Project: City of Moore, New Restroom Facility at Buck Thomas Park

Project No: TAP Project No. 2221

Date: November / 14 / 2025

A110

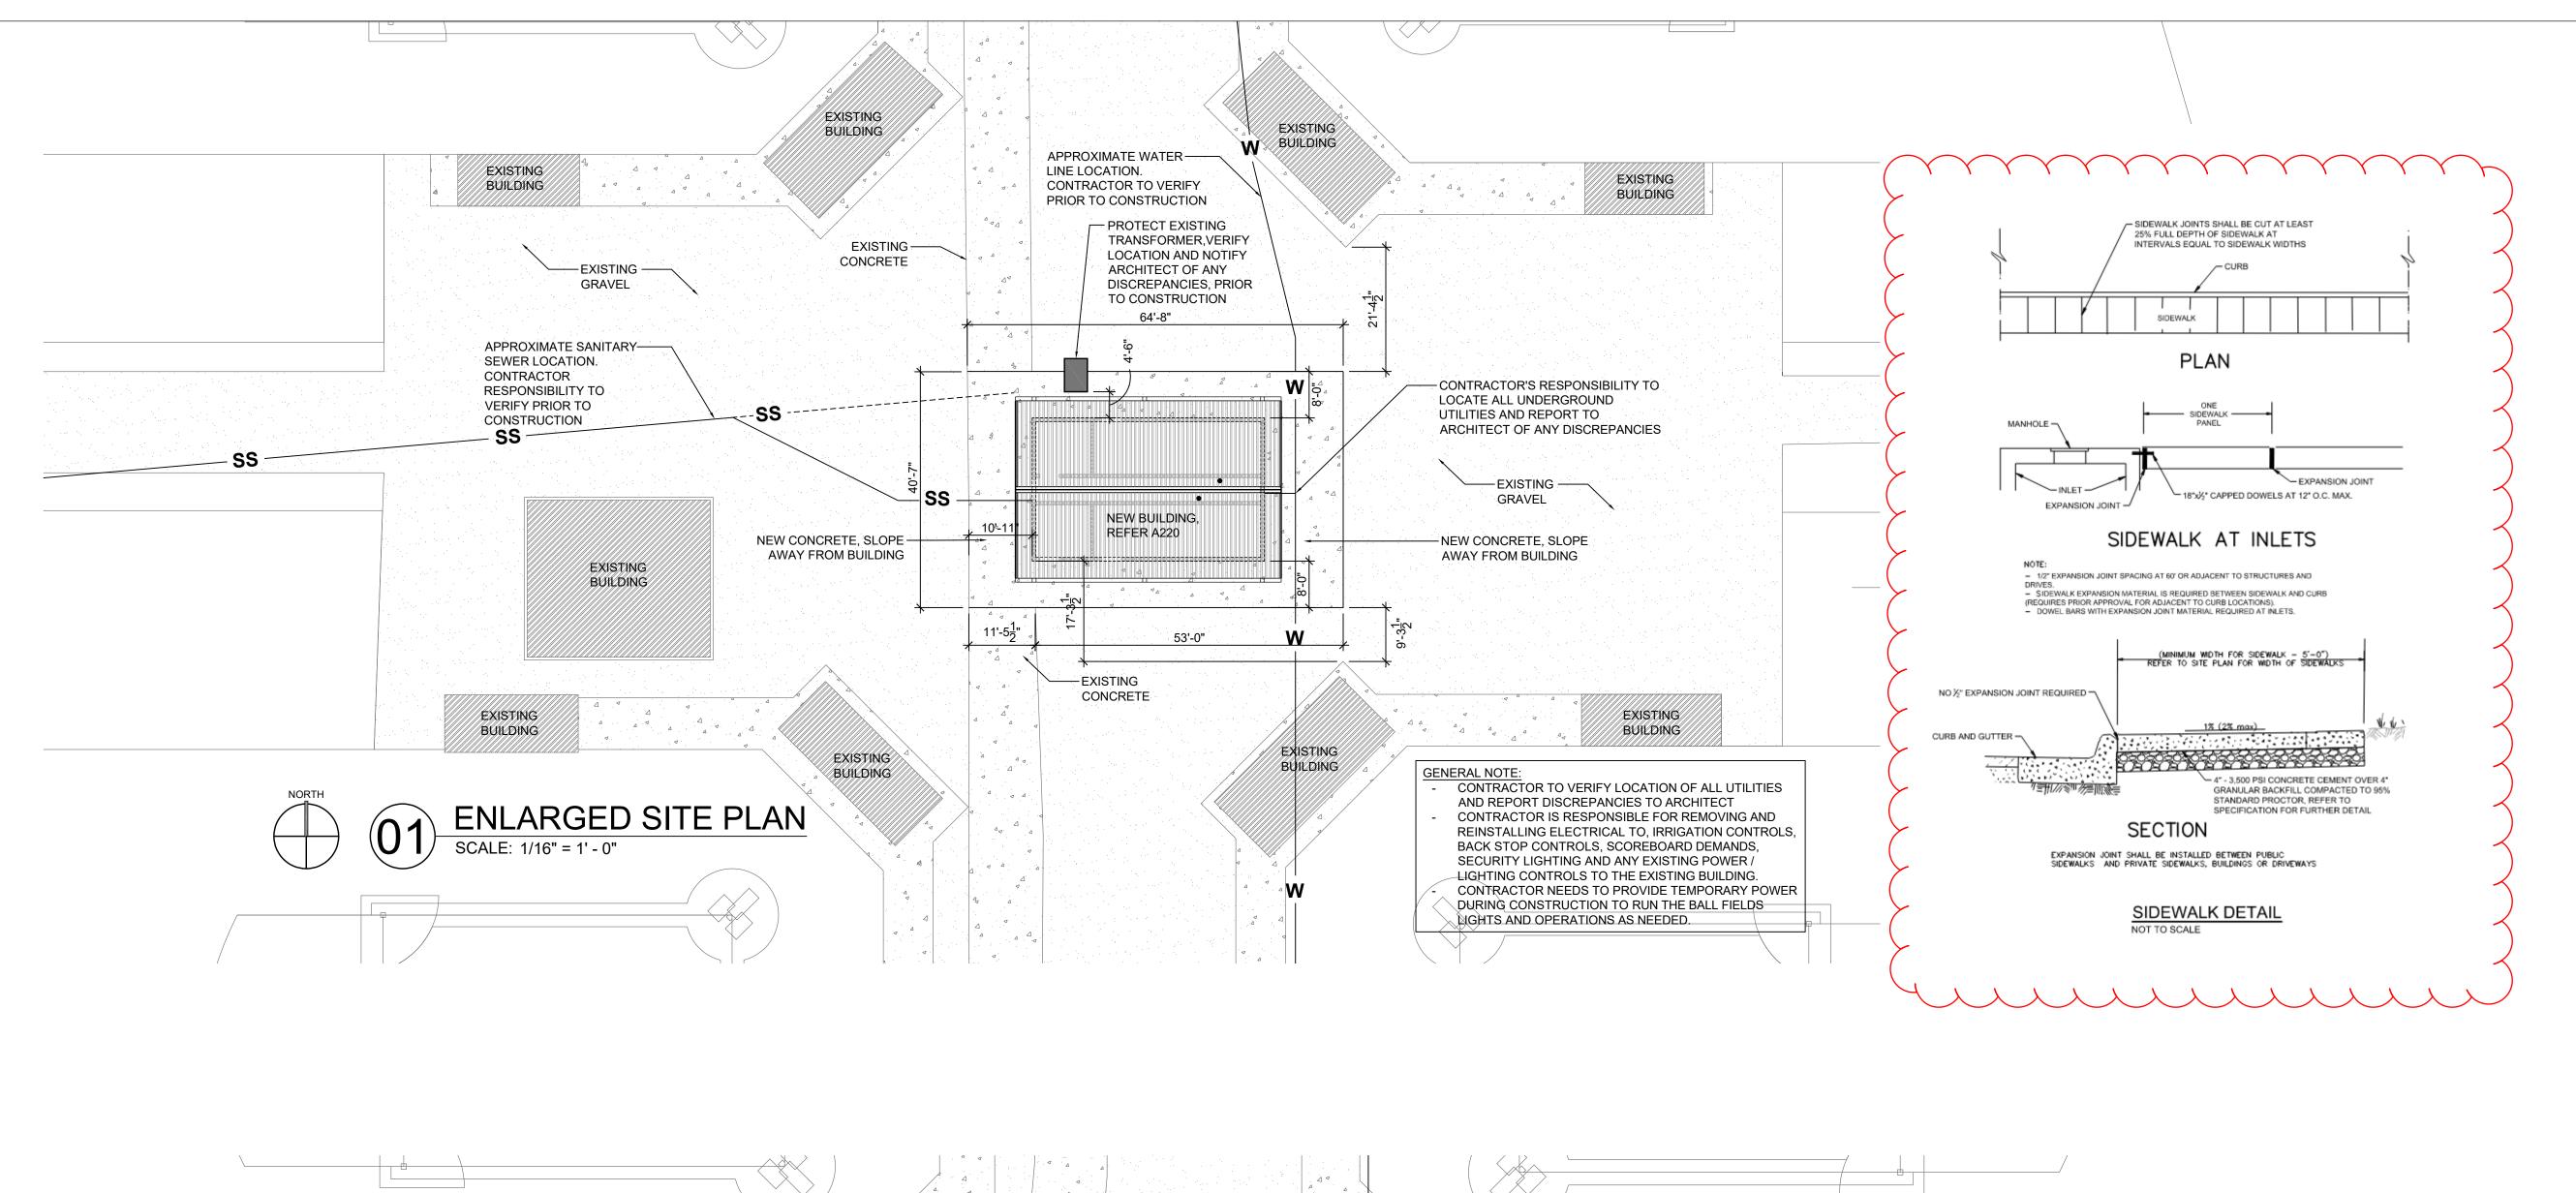
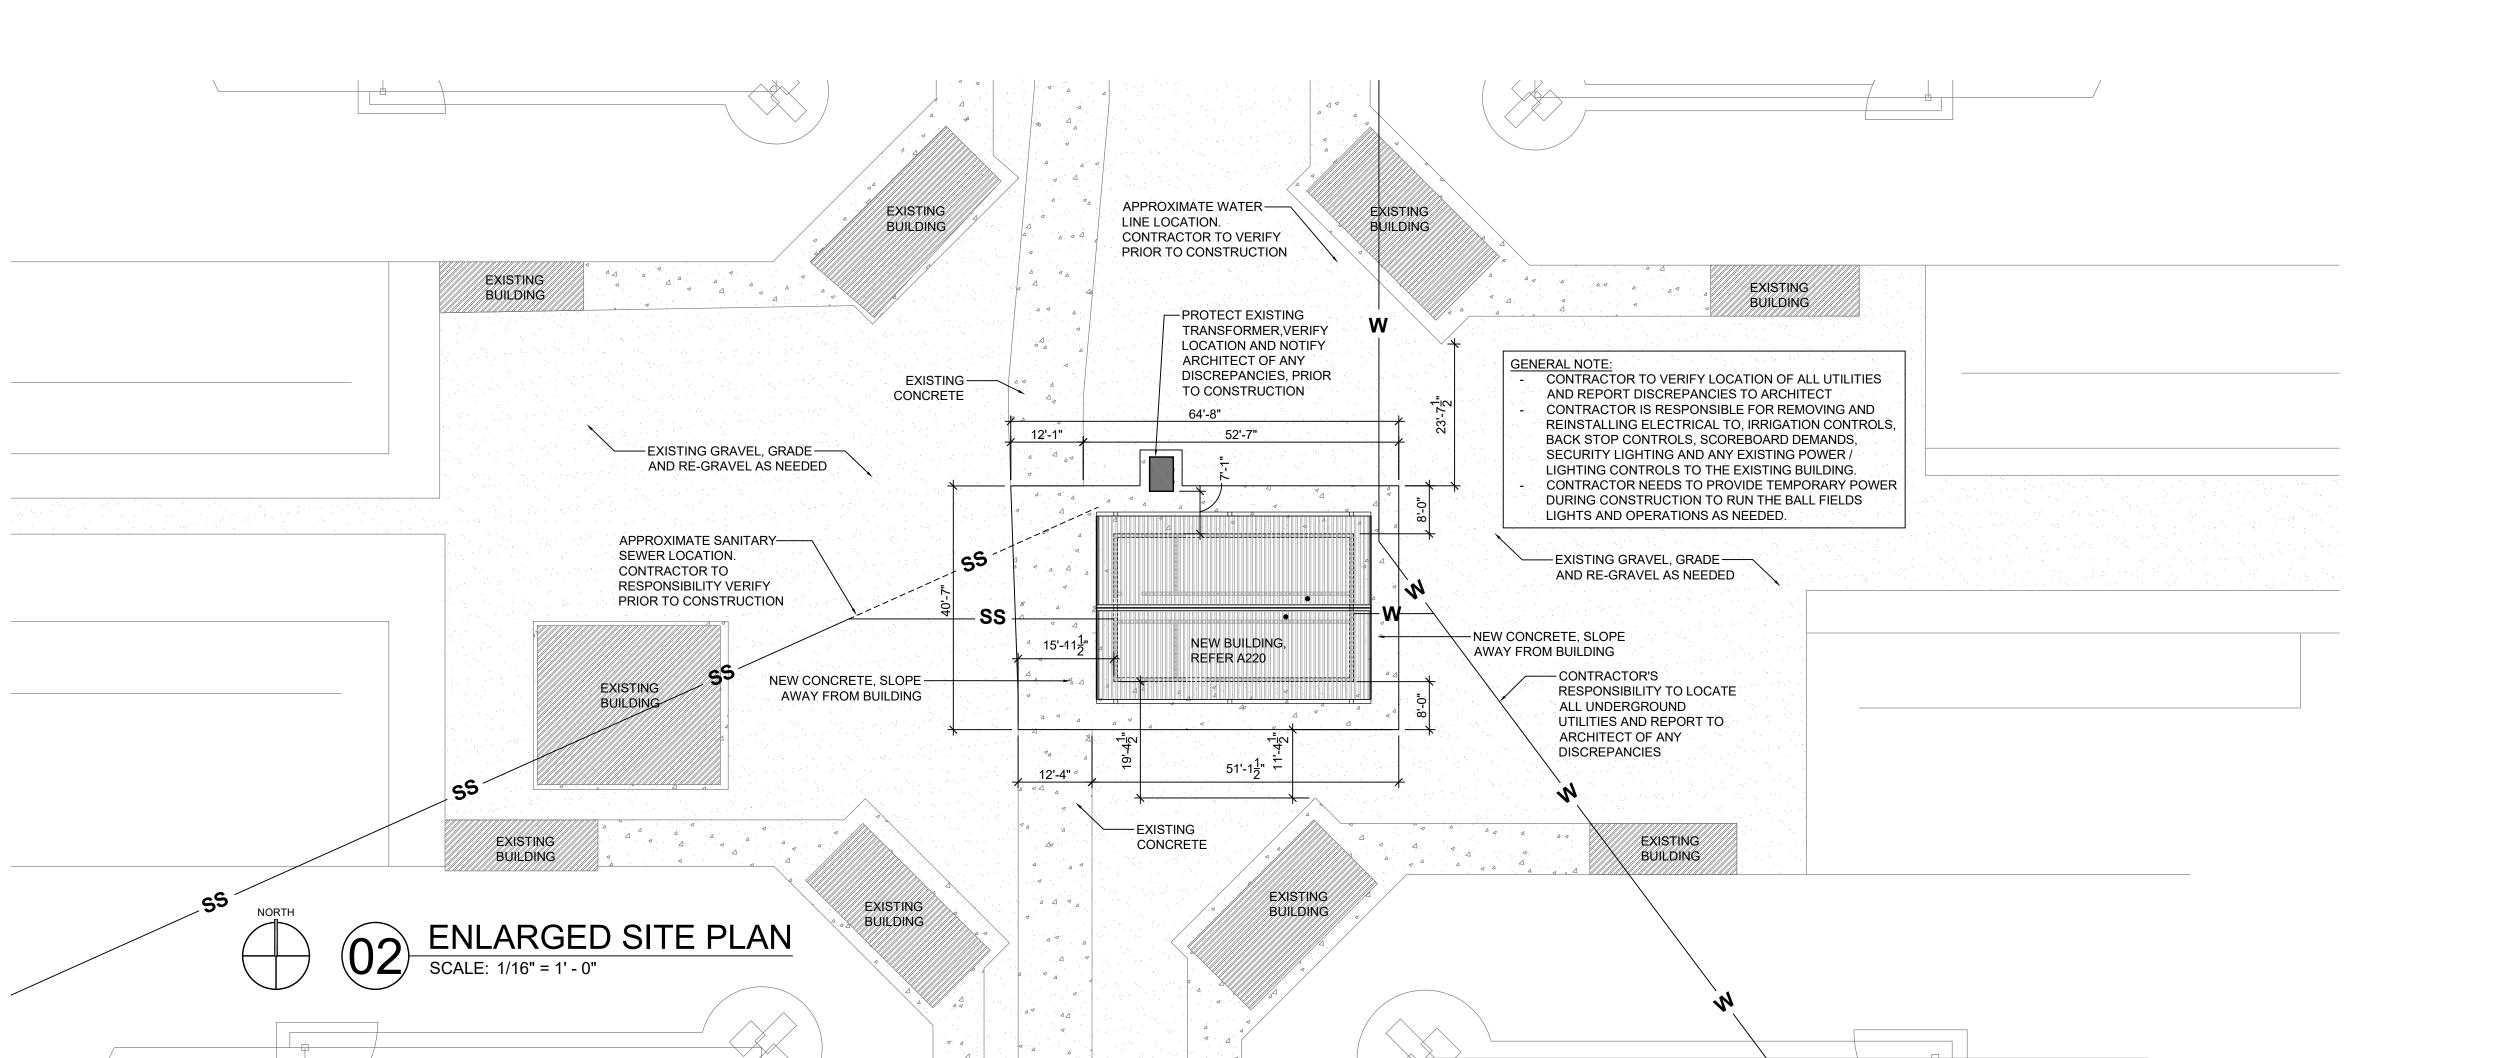
A1.6.1 Refer to Sheet A110 – for concrete details around building.

A1.7.1 How thick is the new concrete around the new building supposed to be? Will it be reinforced? What type of base material is to be used?

ANSWER – The concrete around the building will be 4" – 3500 PSI cement over 4" granular backfill compacted to a 95% standard proctor,

and reinforced with ASTM A 185, 6x6 #10 mesh, along with dowel bars where new concrete is abutting existing concrete @ every 48" O.C.
